Interactive comment on “Joint retrieval of surface reflectance and aerosol properties with continuous variation of the state variables in the solution space: Part 2: Application to geostationary and polar orbiting satellite observations” by Marta Luffarelli and Yves Govaerts

Marta Luffarelli and Yves Govaerts

Received and published: 5 October 2018

Fig. 1. Merged Figure 6

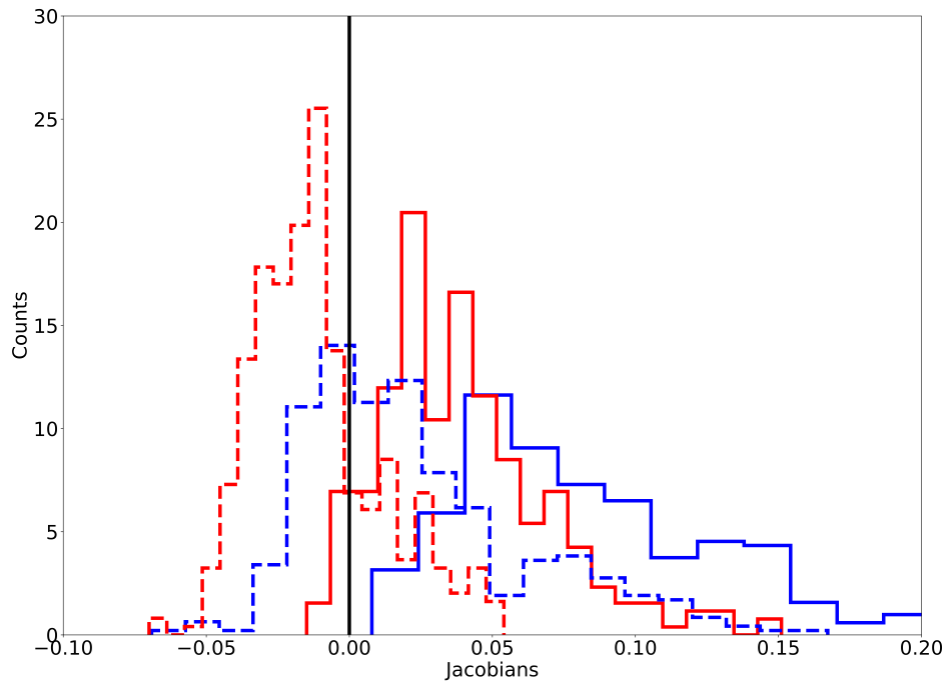
5. Fig 6. : merge the two panels into one, since you compare Carpentras with Zinder.

The merged figure looks quite confusing (Fig. 1). Even changing colors and line styles it would still not be very easy to understand. Keeping the separate panels appears a better choice.

Fig. 2. Bias between CISAR retrieved AOT from SEVIRI (blue) and PROBA-V (red) and AERONET data. The histograms show the distribution of the AERONET data.

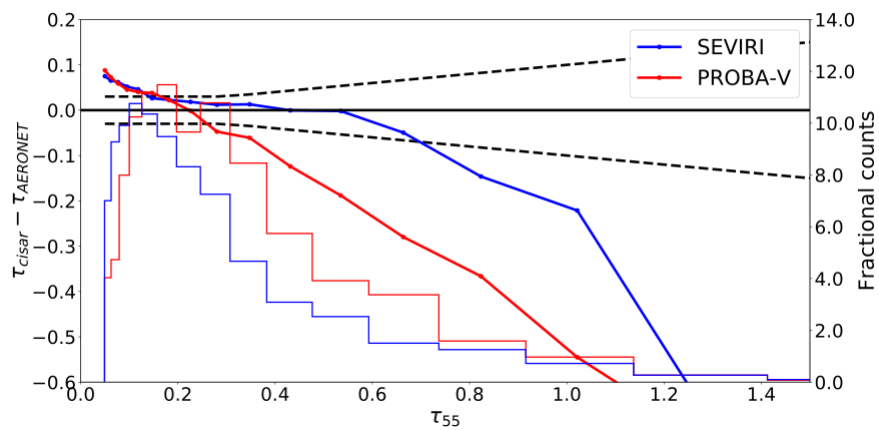
15. Line 456-459. This is one of my most important comments. After the manuscript goes to a great length in describing a very elaborate way to aid the retrievals with “tests”, the results presented in Fig. 14 are clearly not satisfactory (a look at the correlation coefficients immediately tells that the algorithm is not retrieving appropriate AOTs). Then it is commented that at high AOTs the algorithm might fail (then why all the tests?), but that's not too worrisome since it is better if it performs accurately at low optical depths, which are more typical. I might agree with that, but then I have to ask 1) how do you deal with the fact that the 1:1 correlation is as poor at low optical depths; and 2) why the only AOT used for testing was 0.4 in part 1.

The bias between the CISAR retrieval and the AERONET data is shown in Fig. 2, which shows different performances for SEVIRI and PROBA-V. These differences show that

the bias does not only depend on the CISAR algorithm itself, but also on the quality of the processed data. The green histogram shows the AERONET AOT distribution for each bin associated with the CISAR applied SEVIRI AOT product. It can be seen there only few points correspond to $AOT > 0.8$ (less than 5% of the total number of observations), affecting the reliability of the statistics for high values of AOT. The histograms have been added in Fig. 14.

The CISAR AOT product shows overestimation at low AOT and underestimation at large AOT values. The overestimation rapidly decreases as the AOT approaches values of about 0.2. The retrieval is within the GCOS requirement (dashed lines) for $0.2 < AOT < 0.75$. For SEVIRI, two factors might explain the overestimation of the retrieved AOT below 0.2. Firstly, most of the selected AERONET stations are located in Europe as can be seen on Fig. 1 of the revised paper, where the SEVIRI pixel resolution is about 5×8 km (as opposed to 3×3 km at the subsatellite point) which is compared to AERONET point measurement. The probability of residual cloud contamination at this scale might thus explain part of the overestimation (Henderson and Chylek 2005, <https://ieeexplore.ieee.org/document/1499014/authors#authors>). Secondly (and most likely explanation), it should be reminded here that SEVIRI shortest spectral band is 0.67. At low optical thickness, e.g., 0.1, the sensitivity to aerosol at 0.67 is about 2 times smaller than in the blue spectral regions and 1.5 smaller than in the red. A preliminary analysis revealed that the sensitivity of the TOA BRDF to an increase of the AOT from 0.05 to 0.15 is responsible over dark surface to a change comparable with the magnitude of the radiometric uncertainty in the $0.67 \mu\text{m}$ band. Consequently, the retrieval in these cases essentially relies on the prior information despite the very large associated uncertainty (1.0 for the fine mode, 2.0 for the coarse mode). The prior AOT magnitude is taken from the climatology proposed by Kinne et al., 2013 (doi:10.1002/jame.20035.), which exhibit typical mean values around 0.12 in the SEVIRI disk.

Fig. 3. BHR timeseries at 0.6um over Carpentras

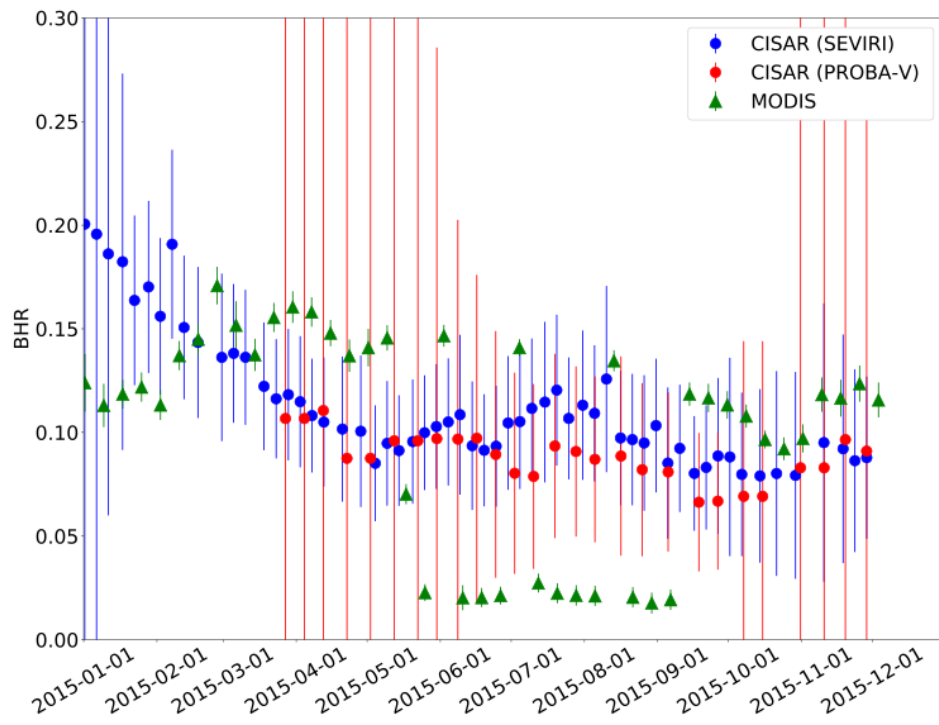
19. Sec. 6.3: how about Carpentras?

The timeseries is shown in Fig. 3 where the MODIS data have been filtered according to their associated quality flag (https://lpdaac.usgs.gov/sites/default/files/public/modis/docs/MODIS_LP_BRDF+Albedo_QA4.pdf). It can be seen that the MODIS timeseries shows some issues and cannot be considered reliable. This might also partially explain the scattering in the BHR density plots in the supplements. Using MODIS to simulate satellite observations in the attempt of proving the FASTRE capability of correctly characterise the satellite observations we underestimated the effort to collect ground truth RPV parameters.
